# Memo

Date: February 5, 2024

Re: Library Apartments, 3325 Toledo Road Development– Detailed Site Plan 01002-04 Discussion and Action

Figure 5 Proposed Transformer Locations

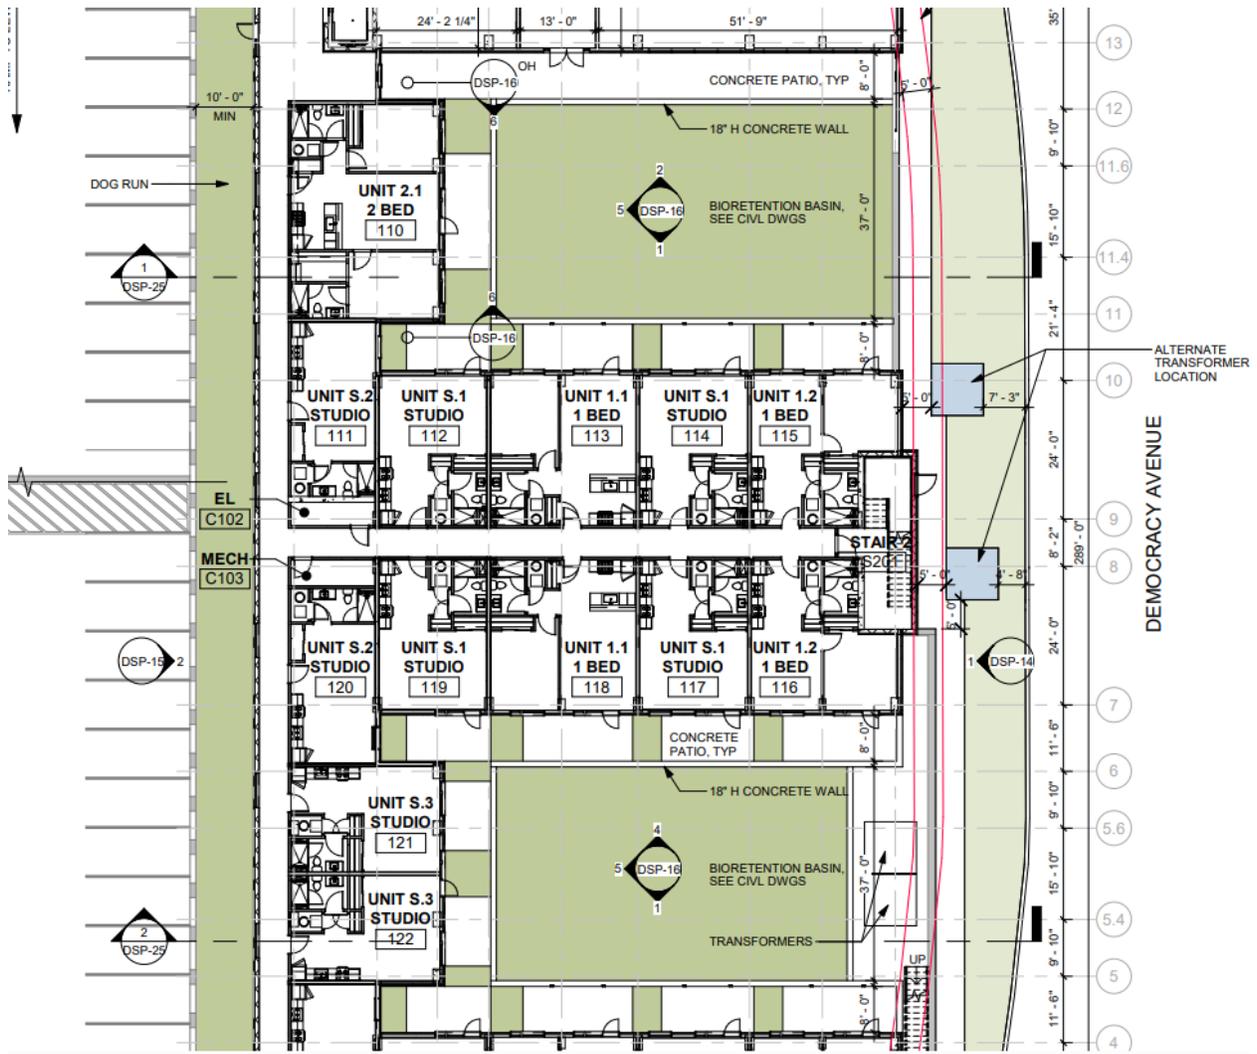
City Staff recommends transformers associated with this development be installed subgrade, consistent with policy guidance per the Prince George’s Plaza TDDP. It is preferable that transformers along Public Road B be required to be subgrade. Subgrade transformers are more secure, visually appealing, and

aligned with the intent of the TDDP than above-grade transformers.

The applicant has proposed the installation of screening devices around the transformers as consistent with the TDDP. Staff prefers the option one which is to relocate the proposed transformers within the southern-most courtyard subject to approval by PEPCO. Alternatively, the second option is to relocate

the transformers away from the corner of Democracy Avenue and Toledo Road with decorative metal screening (Figure 5) . Screening from the public view is essential, particularly along the east side of the property and we believe this will offer reduced impact and no impact on the urban streetscape. See relevant excerpt below:

The locations of the applicant’s proposed screening devices and proposed alternate locations can be seen in figures 5 & 6.

1. All transformers associated with this development shall be relocated south within the southern courtyard pending the approval by PEPCO. Alternatively, all transformers shall be relocated further south and properly screened as indicated in Sheet DSP-25.
